5th Review
PRCCP20230970
May 2024

East Town Crossing
Phase One
Pioneer Way & Shaw Road
Puyallup, WA

Overall Landscape Plan

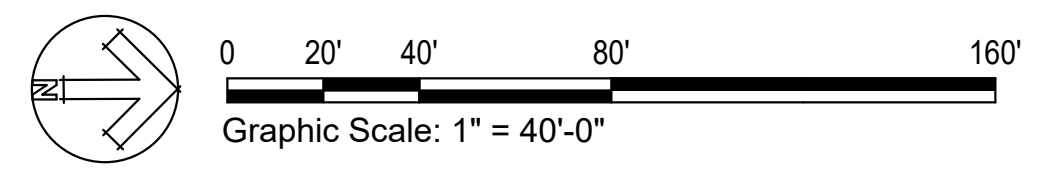
Add the following note: "Maintain minimum 10ft separation between landscape trees and underground wet utilities and fire hydrants."
[Landscape Plans Sht L1.0; Pg 1 of 17]

Provide a landscape plan with all underground wet utilities overlaid on the plan per City Standards.
[Landscape Plans Sht L1.0; Pg 1 of 17]

Added note to L1.1, L.2, L1.3, and L1.4

Overlaid underground wet utilities on plans
